Floodplain Development Permit Application

River and Riparian Restoration Project for the Swan Property
June 4, 2024

Amendment to River and Riparian Restoration Project for the Swan Property

River and Riparian Restoration Project for the Swan Property: Stream Alteration and Floodplain Development Permit Applications - Amended

1. Site plan for Area 4 (Drawing #3) is replaced with Revision C of the drawing included herein. All other drawing sheets are unchanged.
2. Line 3 of Table 1 of the narrative dated June 7, 2024 is changed to read as follows:

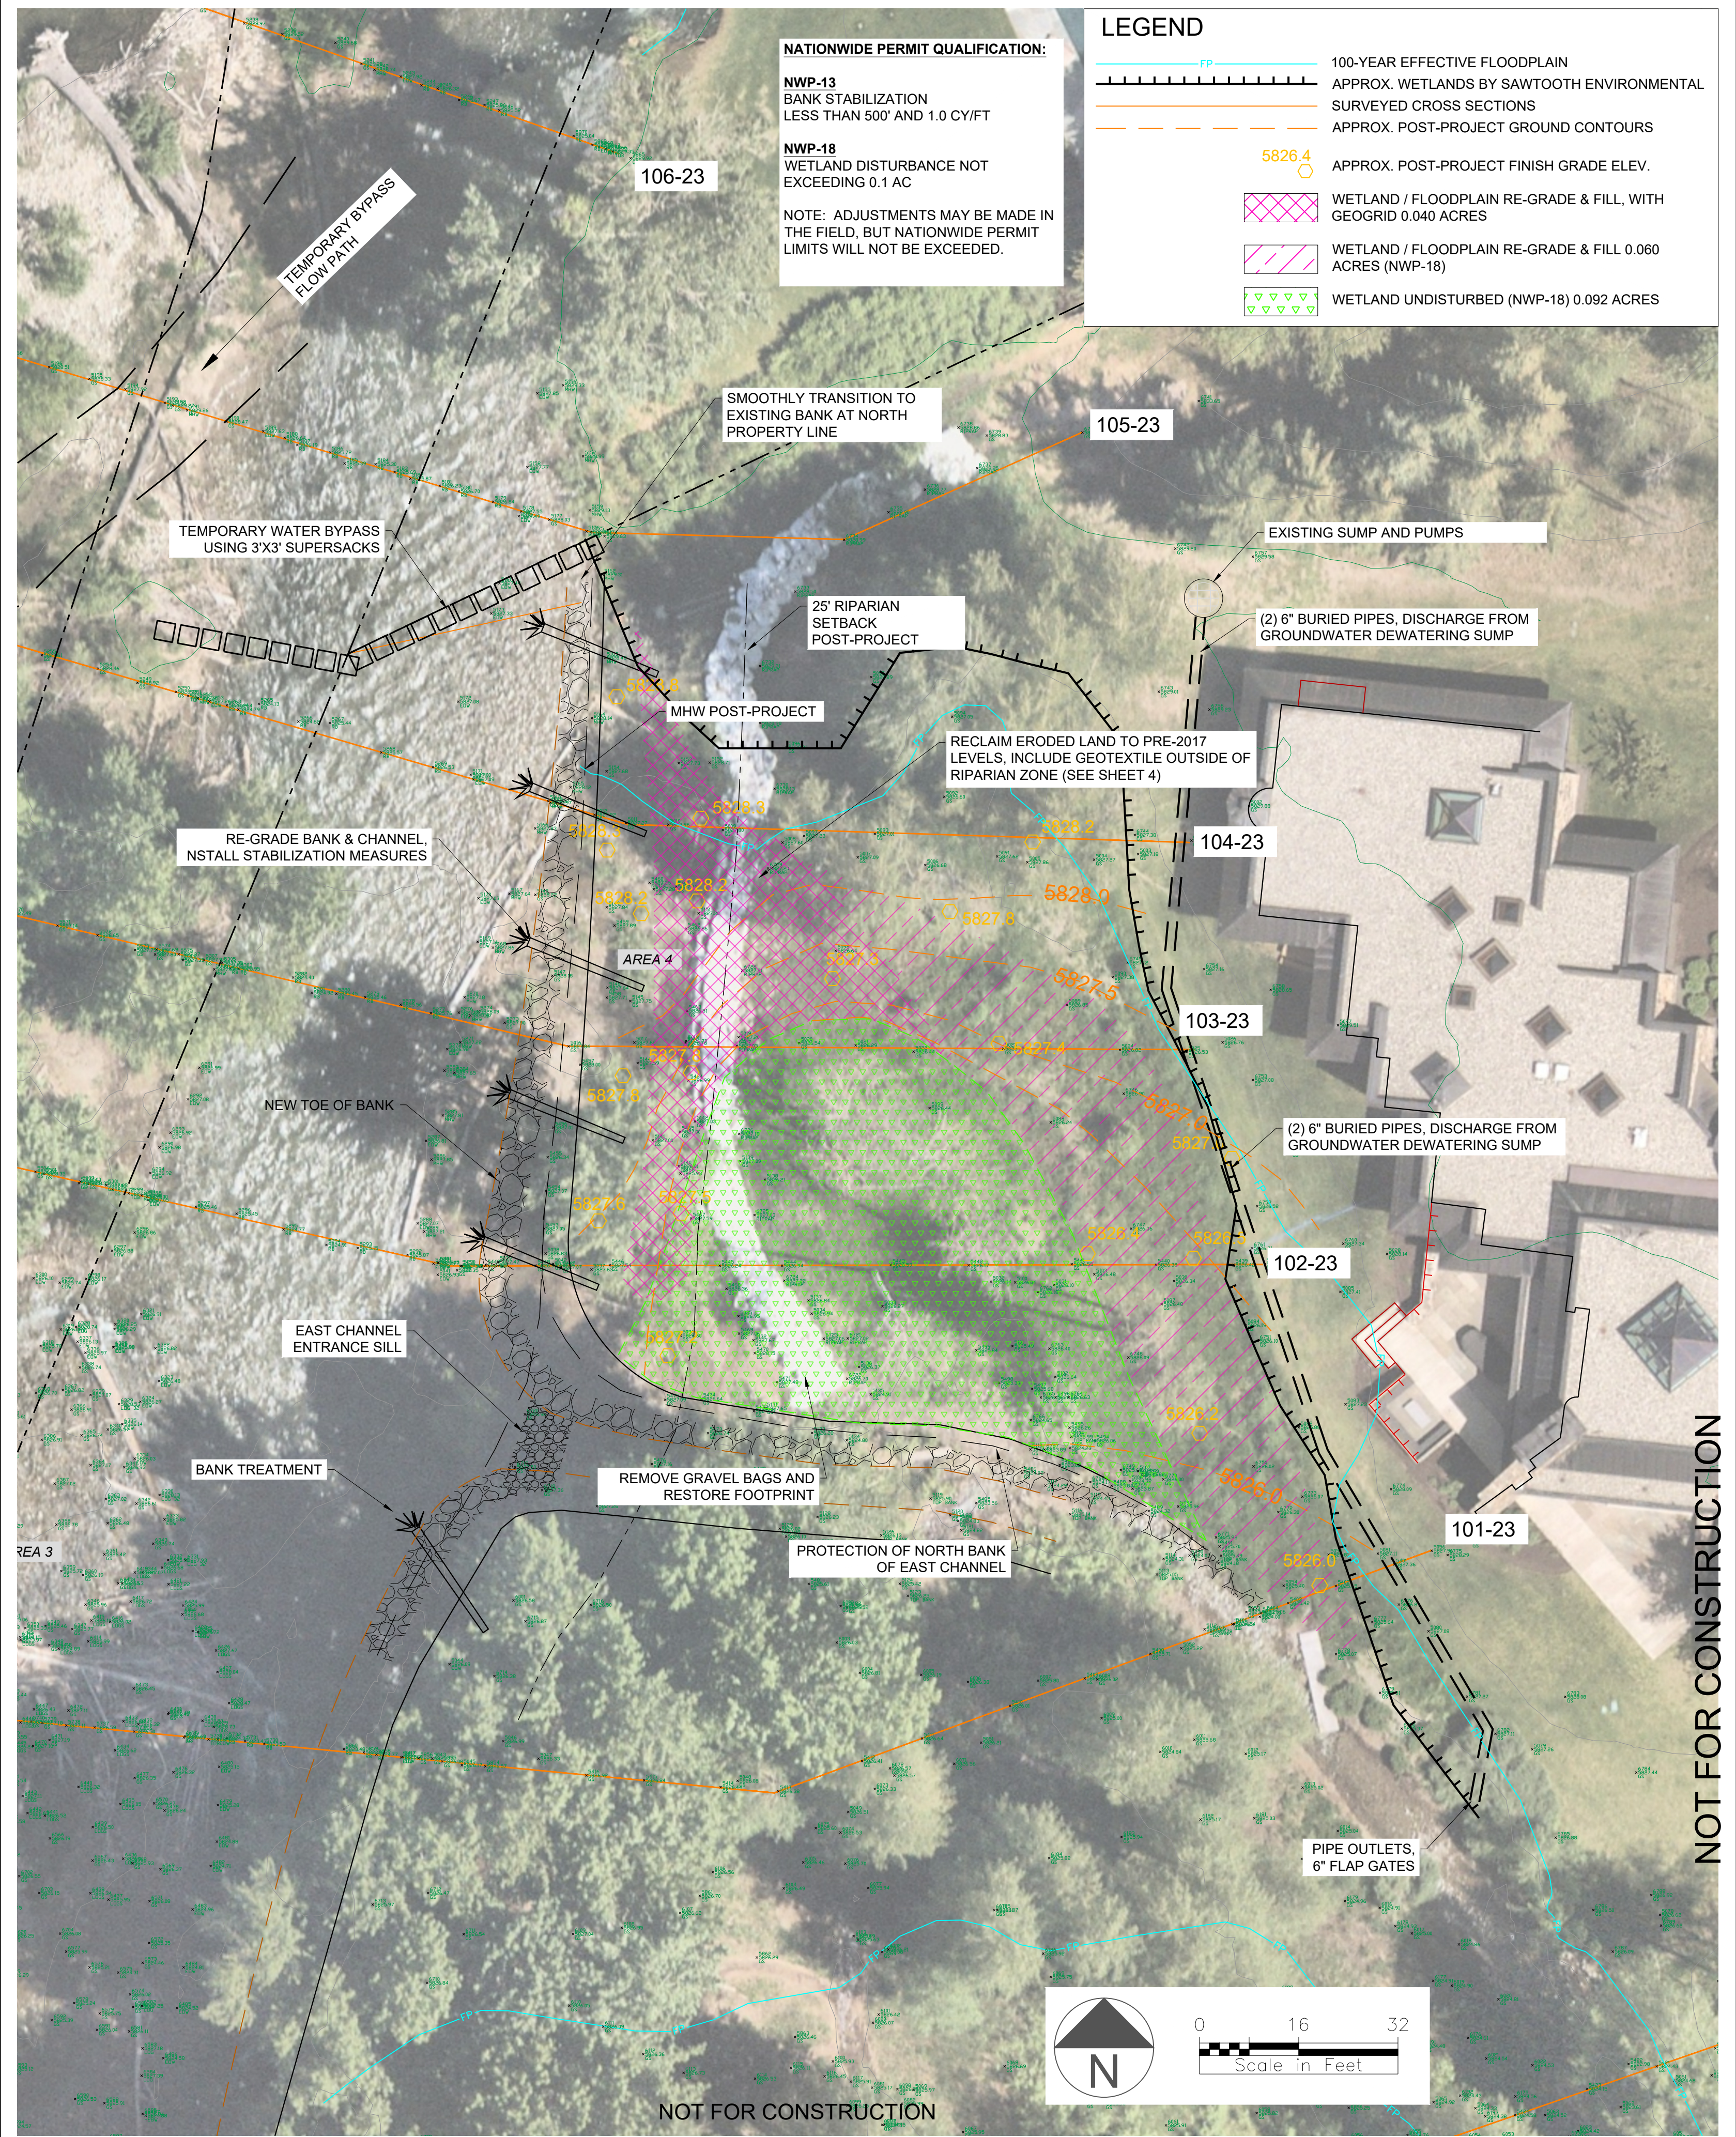
This amendment concerns permit applications submitted on June 10, 2024 for the Swan project in Ketchum, Idaho. The project design has been changed so that Area 4 of the project, i.e. restoration of the eroded floodplain, will involve a fill area of 0.10 acres or less. This change affects Section D.3. of the original narrative dated June 7, 2024. No other changes are being made to the project.

The reason for this change is that the Corps of Engineers now considers most of Area 4 to be jurisdictional wetlands, and it is necessary to remain under the 0.10 acre threshold so that the activity may be covered by Nationwide Permit 18. Sawtooth Environmental was retained to evaluate the site and delineate an approximate wetland line, which is shown on the revised site plan.

The restoration will include three types of treatment, as shown on the site plan Revision C:

1. Re-graded, restored and protected area near the bank and in the area where the most significant sheet flow will occur as the river bank overtops during high water. This area will be protected with the subsurface geotextile as previously contemplated in order to prevent the downcutting that has previous occurred.
2. Re-graded and restored land that will not involve placement of the geotextile. This area will receive sheet flow but is less at risk of erosion.
3. Undisturbed wetland. This is the central area of the floodplain restoration and is slightly lower than surrounding land. It is the main region of sheet flow during high water events. This area has established very well with native vegetation and should be self-sustaining the established vegetation will provide a degree of erosion protection.

3. The project revegetation plan is revised to remove plantings from the undisturbed wetland area. This area is to remain undisturbed.

AREA 4 SITE PLAN

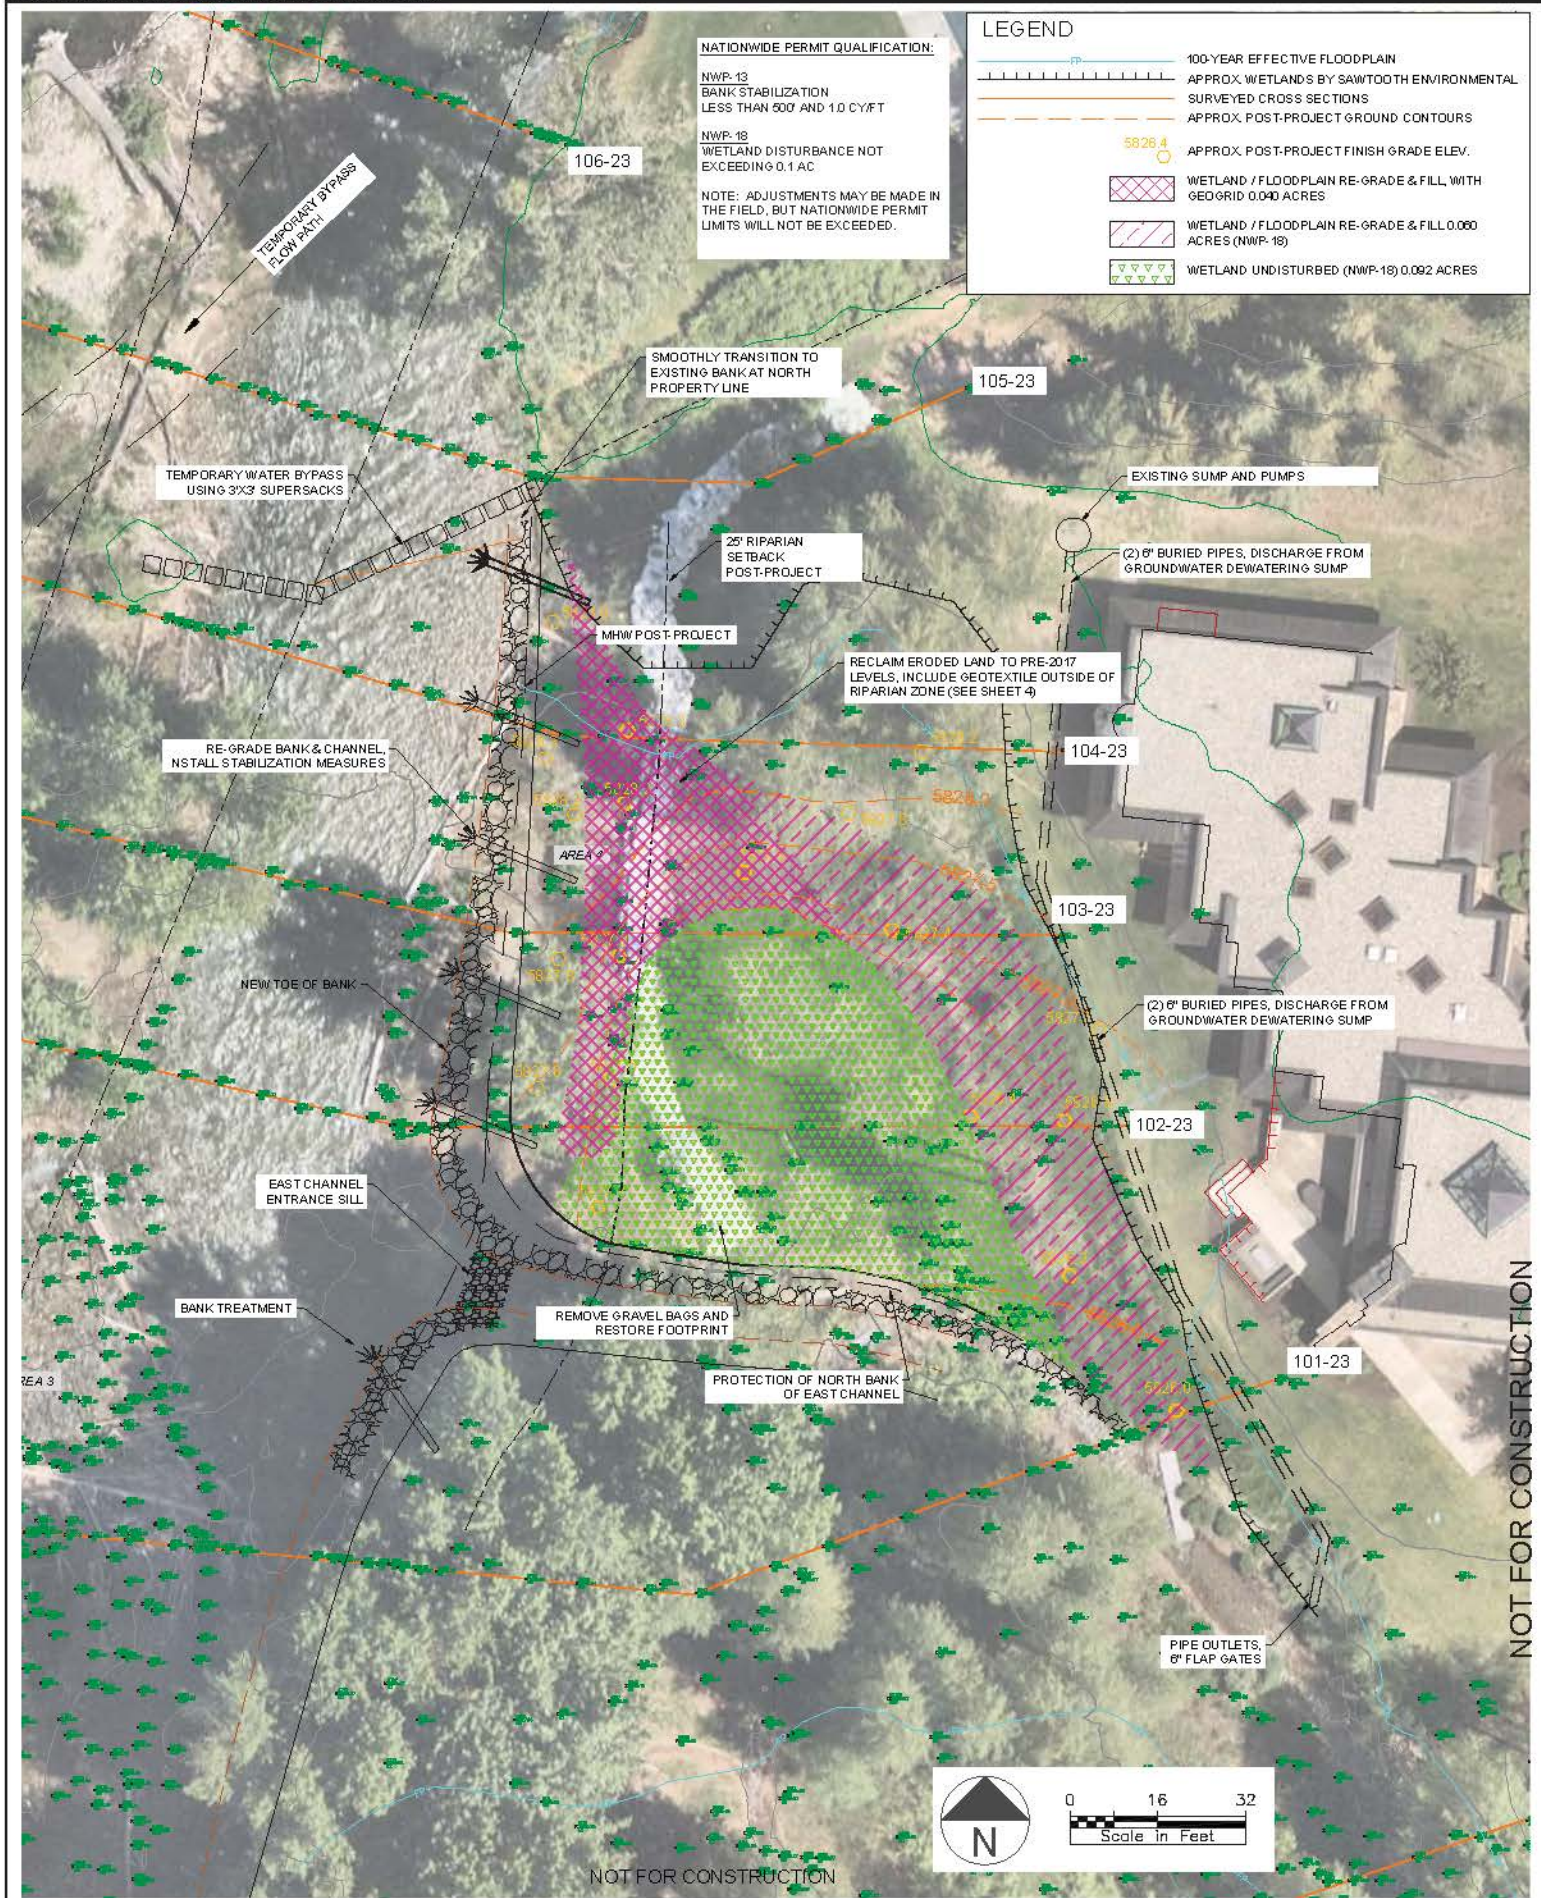
This amendment concerns permit applications submitted on June 10, 2024 for the Swan project in Ketchum, Idaho. The project design has been changed so that Area 4 of the project, i.e. restoration of the eroded floodplain, will involve a fill area of 0.10 acres or less. This change affects Section D.3. of the original narrative dated June 7, 2024. No other changes are being made to the project.

The reason for this change is that the Corps of Engineers now considers most of Area 4 to be jurisdictional wetlands, and it is necessary to remain under the 0.10 acre threshold so that the activity may be covered by Nationwide Permit 18. Sawtooth Environmental was retained to evaluate the site and delineate an approximate wetland line, which is shown on the revised site plan.

The restoration will include three types of treatment, as shown on the site plan Revision C:

1. Re-graded, restored and protected area near the bank and in the area where the most significant sheet flow will occur as the river bank overtops during high water. This area will be protected with the subsurface geotextile as previously contemplated in order to prevent the downcutting that has previous occurred.
2. Re-graded and restored land that will not involve placement of the geotextile. This area will receive sheet flow but is less at risk of erosion.
3. Undisturbed wetland. This is the central area of the floodplain restoration and is slightly lower than surrounding land. It is the main region of sheet flow during high water events. This area has established very well with native vegetation and should be self-sustaining the established vegetation will provide a degree of erosion protection.

1. Site plan for Area 4 (Drawing #3) is replaced with Revision C of the drawing included herein. All other drawing sheets are unchanged.
2. Line 3 of Table 1 of the narrative dated June 7, 2024 is changed to read as follows:

3. The project revegetation plan is revised to remove plantings from the undisturbed wetland area. This area is to remain undisturbed.
